# Access Compliance Report

## Public Rights-of-Way

### (Curb Ramps)

Intersection ID: 46785	Main Street: DOMINION_VILLAGE_DR	Cross Street: AUTUMN_HARVEST_LN	Location: S
ADA ID: B7F2380EE910	Ramp Type: PerpDiag	Initial Pass/Fail: Fail	Overall Compliance: No
Codes/Mitigation Info/Possible Solution		Field Measurements/Component Compliance	
Severity Score: 10

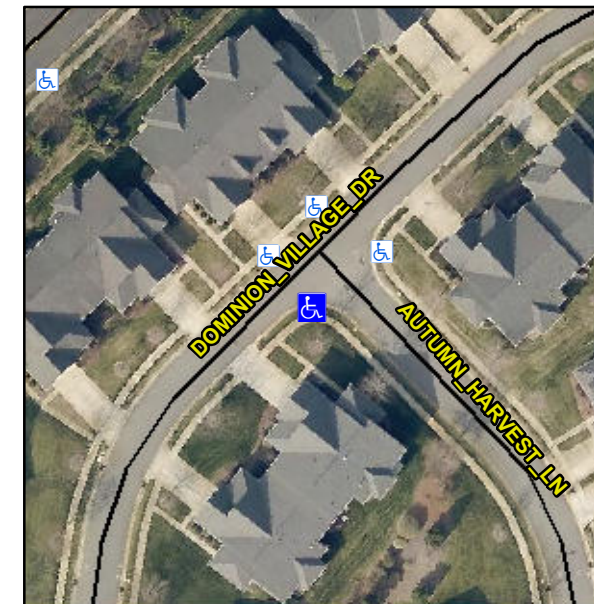
**Not Found, R304.5.1, R304.5.3**

Compliance	Description	Data	Compliance	Description	Data
N/A	Ramp Length (in)	48.0	Yes	Ramp Slope (%)	5.3
No	Ramp Width (in)	36.0	No	Ramp XSlope (%)	2.8
N/A	Flare Type LT	N/A	N/A	Flare Type RT	N/A
N/A	Flare Slope LT (%)	N/A	N/A	Flare Slope RT (%)	N/A
N/A	Flare Traversable LT?	N/A	N/A	Flare Traversable RT?	N/A
N/A	Landing Length (in)	N/A	N/A	DWS Provided?	N/A
N/A	Landing Width (in)	N/A	N/A	DWS Contrast?	N/A
N/A	Landing Slope (%)	N/A	N/A	DWS Length (in)	N/A
N/A	Landing X Slope (%)	N/A	N/A	DWS Full Width?	N/A
N/A	Landing Curb? (Y/N)	N/A	N/A	DWS Offset (in)	N/A
N/A	Shared Landing?	N/A			
N/A	Gutter Ponding?	N/A	N/A	Gutter Slope (%)	N/A
N/A	Gutter Lip Ht (in)	N/A	N/A	Gutter X Slope (%)	N/A
N/A	Painted X Walk1?	No	N/A	Painted X Walk2?	No
	X Walk 1 Direction	To NE		X Walk 2 Direction	To NW
N/A	X Walk 1 Width (in)	N/A	N/A	X Walk 2 Width (in)	N/A
	X Walk 1 Slope (%)	5.1		X Walk 2 Slope (%)	8.7
	X Walk 1 X Slope (%)	8.3		X Walk 2 X Slope (%)	3.2

N/A	Ramp inside XWalk1?	N/A	N/A	Ramp inside XWalk2?	N/A
	Road Slope (%)	4.9	N/A	Clear Space?	N/A
	Road X Slope (%)	6.0	N/A	Clear Space to XWalk (in)	N/A
N/A	Any Obstructions?	N/A	N/A	Storm Grate/Utility Hazard?	N/A
	Obstruction Type			Storm Grate/Utility Type	
		N/A			N/A
			Yes	Surface Condition? (G/P)	Good

**Remove & Replace Curb Ramp With Two New Directional Ramps or Equivalent.**
